# Planning Services Sign Permit Review Form

Date of Submittal	Application Number	Applicant	Landowner
8/2/2022	SIGN2208-0001	Ginn Charles	Calvary Baptist Church

Contact Person	Contact Number	Sign Location	PIN Number
Charles Ginn	910-514-2327	SW corner of property	0518-80-0033.000

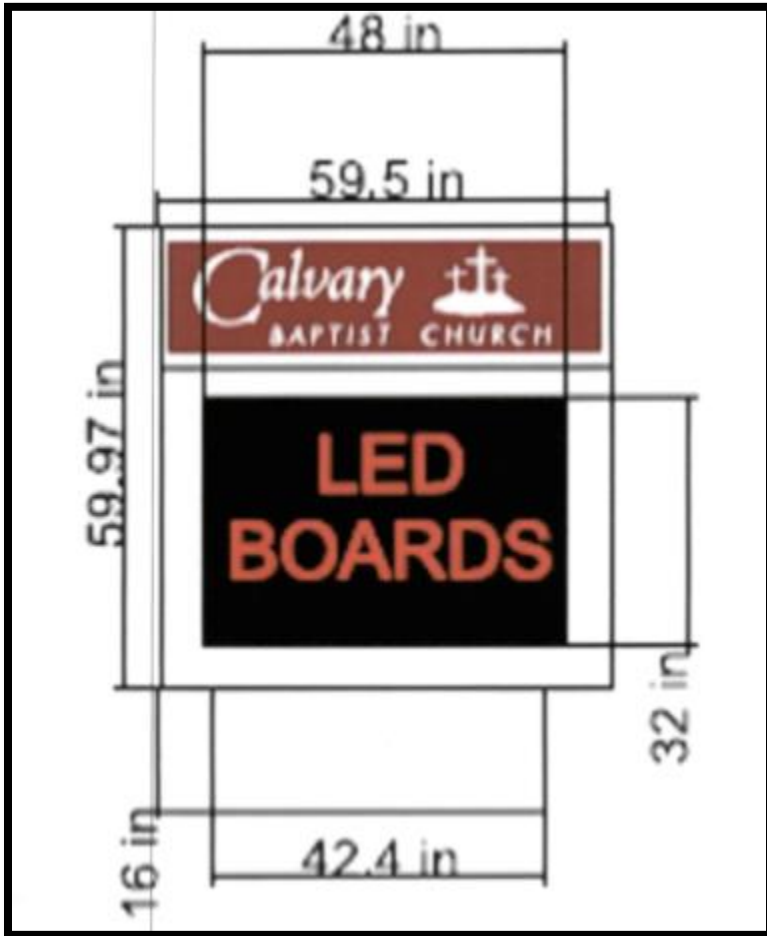
Comments	<p style="margin: 0;"><b><u>Information Comment Only</u></b></p> <ul style="list-style-type: none"> <li>- <b><u>Must remove old sign before approval</u></b></li> <li>- <b>Electronic message board portion of sign cannot change messages more than 7 times per minute. No animated presentations or animated change of frame is allowed. This will be checked as a part of the zoning inspection.</b></li> </ul>
----------	--
